Re: Active Traffic Management and SR104 Holding Lanes – Summary Memo

Re: ATMS Design for Shoulder Holding Lanes

Subject: RE: [EXTERNAL] POK Kingston Ferry Holding Lanes - Final Documents

| LINDVOG HOLDING AREA | CSP1 |

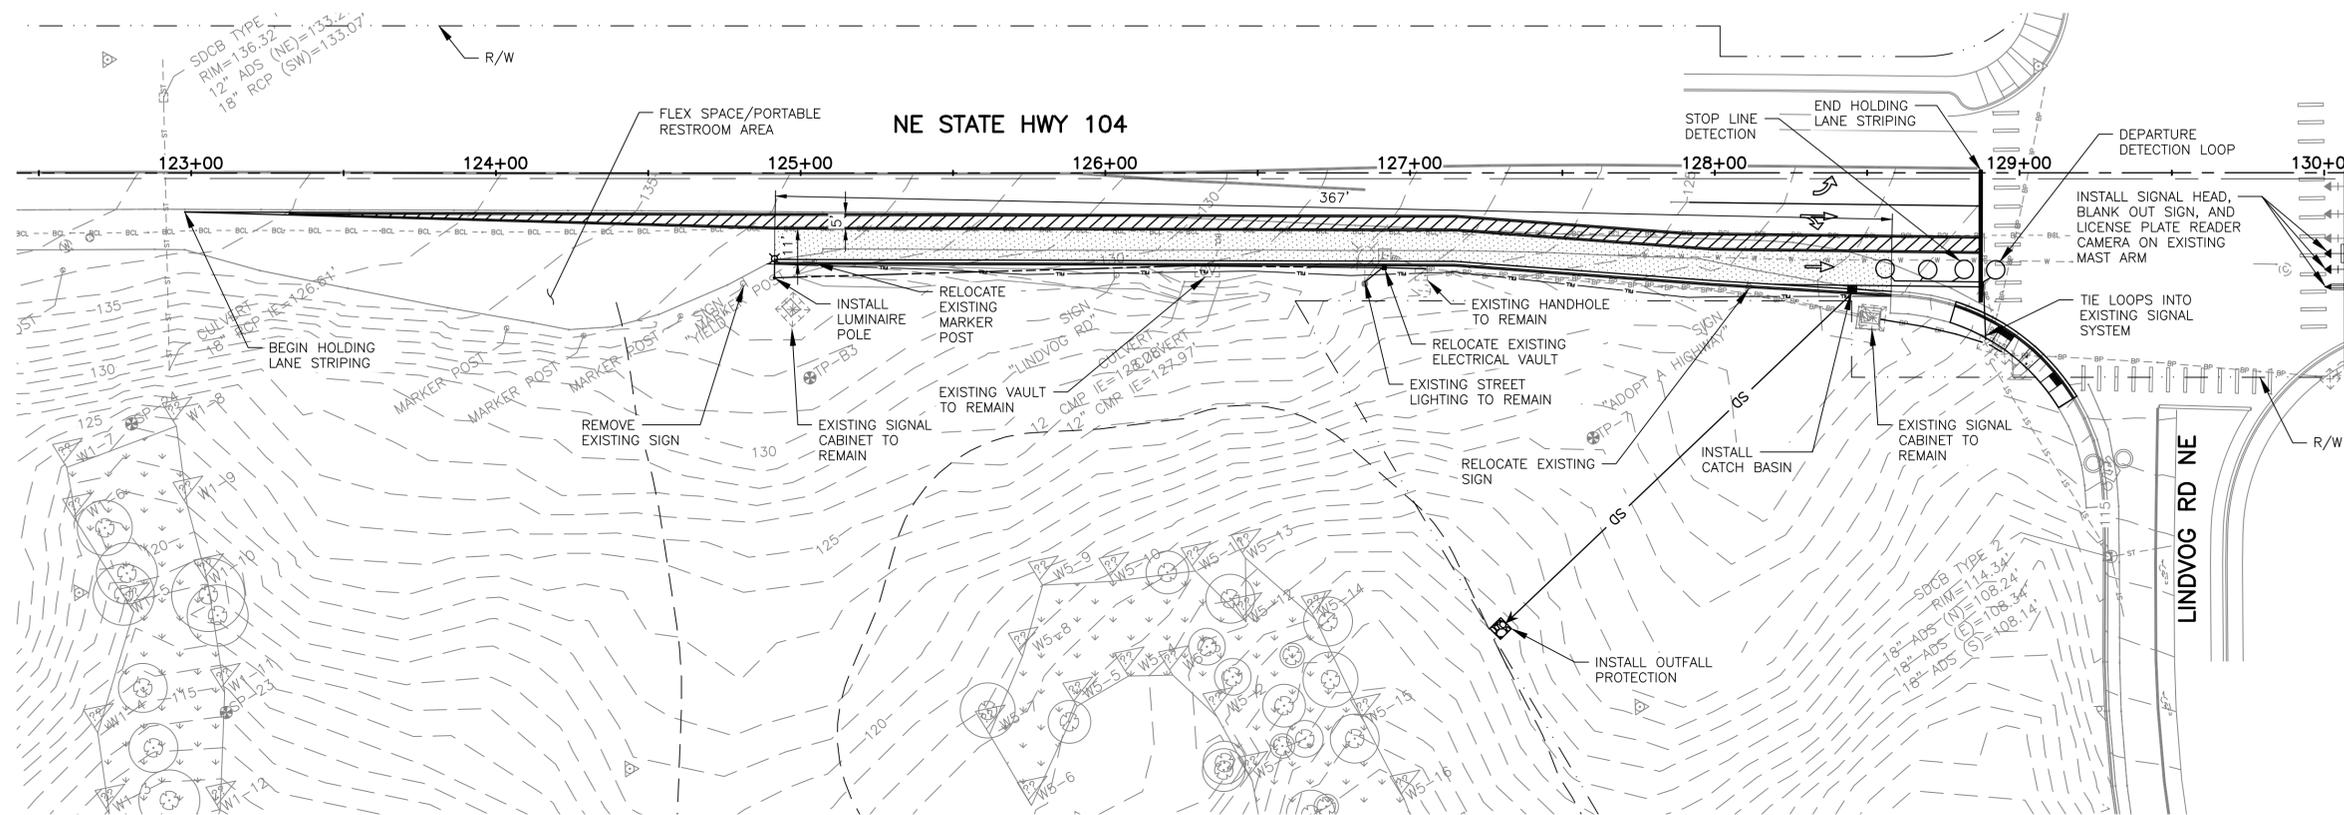
- The plan sheet appears to show 600' of storage (Sta 123+00 to 129+00), but the memo states 750' of storage. What's accurate? **Documents have been updated.** That equates to about 24-30 vehicles, respectively, and the project removes the current vehicle storage on SR 104 downtown, so there is a net loss in parking. With the limited storage, is the expectation that any additional vehicles would store on the upstream shoulder? **Yes. The intent of the project was to minimize vehicles waiting on the shoulder between Lindvog and downtown. Storage in downtown will still remain but the intent is to minimize this queuing as much as possible.** If upstream storage reaches capacity, are vehicles expected to turn around and try again? **No. Vehicles will behave as they are today and queue on the shoulder.** Will upstream VMSs be provided as part of this project to communicate to those upstream motorists? **VMS will not be provided as part of this project. However, we have noted that VMS should be considered in the future if additional funding for this project is available.**
